33. Data Terminal Equipment (DTE) Power via Media Dependent Interface (MDI)

33.2.4 PSE state diagrams

Figure 33–1—PSE monitor overload state diagram

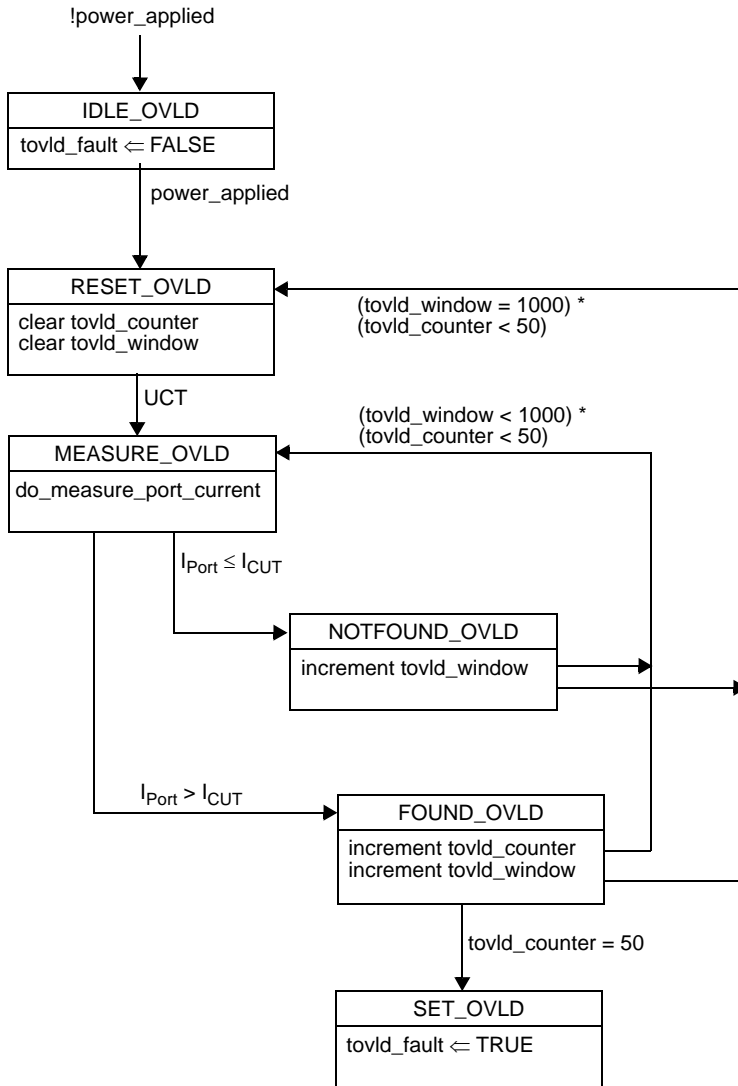
tovid_counter

A variable used as a counter to keep track of the cumulative time the current at the PI has exceeded ICUT.

tovid_window

A variable used as a counter for the purpose of calculating the IPort overload duty-cycle.

tovid_fault

A variable indicating an overload fault has occurred.

~~tovid_timer~~

~~A timer used to monitor the duration of an overcurrent condition, see T_{ovld} in Table 33-11.~~

do_measure_port_current

This function measures the current at the PI over a 1 ms period.
